SURVEILLANCE REQUIREMENTS (Continued)

PALO VERDE - UNIT 1

3/4 8-4

AMENDMENT NO. 9

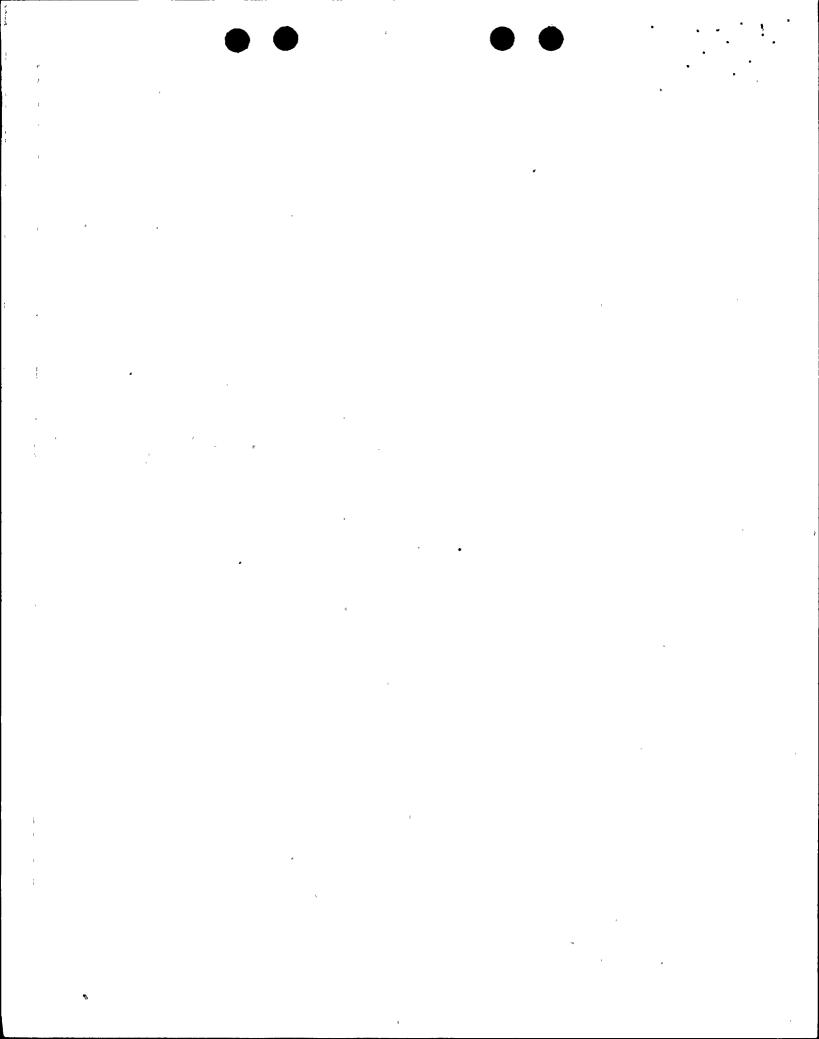
- d. At least once per 18 months during shutdown by:
 - 1. Subjecting the diesel to an inspection in accordance with procedures prepared in conjunction with its manufacturer's recommendations for this class of standby service.
- 2. Verifying the generator capability to reject a single largest load of greater than or equal to 839 kW (Train B AFW pump)

Train A Normal Water Chiller for emergency diesel generator B or 696 kW for emergency diesel generator A (Train A HPSI pump) while maintaining voltage at 4160 ± 420 volts and frequency at 60 ± 1.2 Hz.

Insert 4.8.112.0.3

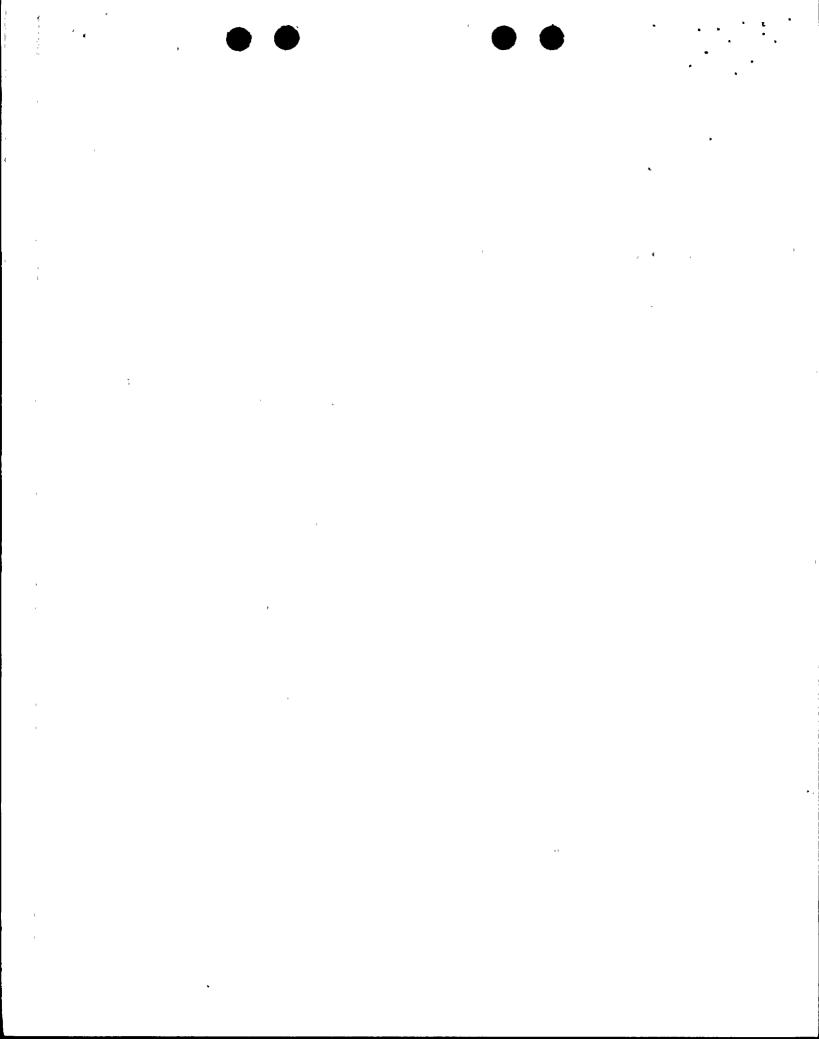
During the first 2 hours of this test, the diesel generator shall be loaded to an indicated 5800-6000 kW** and during the remaining 22 hours of this test, the diesel generator shall be loaded to an indicated 5200-5400 kW**. Within 5 minutes after completing this 24-hour test, perform Surveillance Require-

ment 4.8.1.1.2.d.8.b).***
(5800-6000)

Insert 4.8.1.1.2.d.11

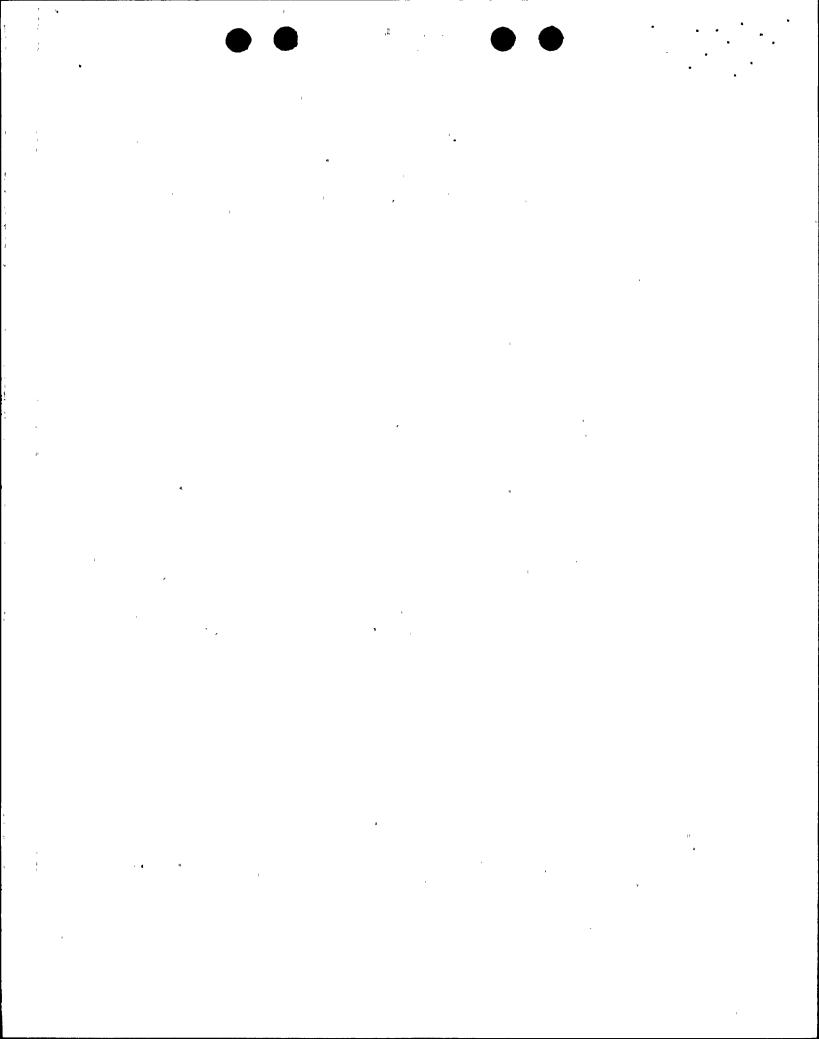
Verifying the generator capability to reject a single largest load of greater than or equal to 839 kW (Train B AFW pump)
for emergency diesel generator B or 696 kW for emergency diesel generator A (Train A HPSI pump) while maintaining voltage at 4160 ± 420 volts and frequency at 60 ± 1.2 Hz.***

INSERT 4.8.1.1.2, 2,3

****Deferred until cycle 3 refueling outage.

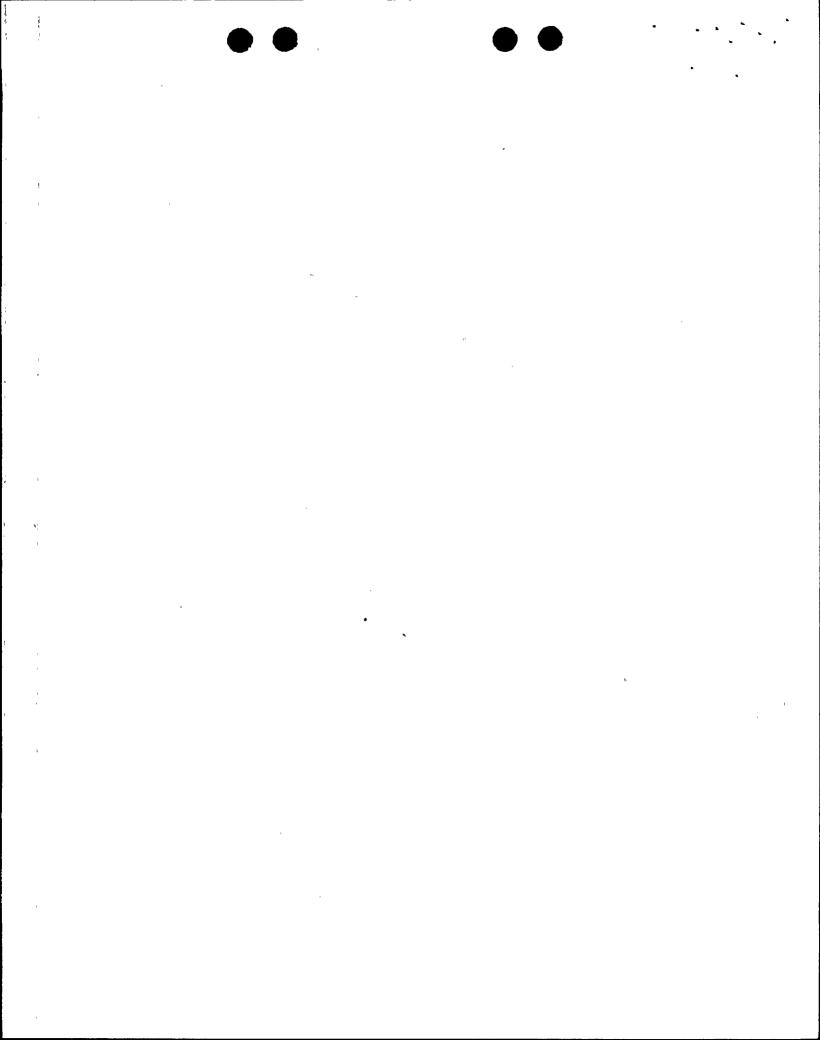
Verifying the generator capability to reject a single largest load of greater than or equal to 839 kW (Train B AFW pump) Train A Normal Einter Chiller for emergency diesel generator B or 596 kW for emergency diesel generator A (Train-A-HPSI-pump) while maintaining voltage at

Insert 4.8.112.0.3

5800-6000
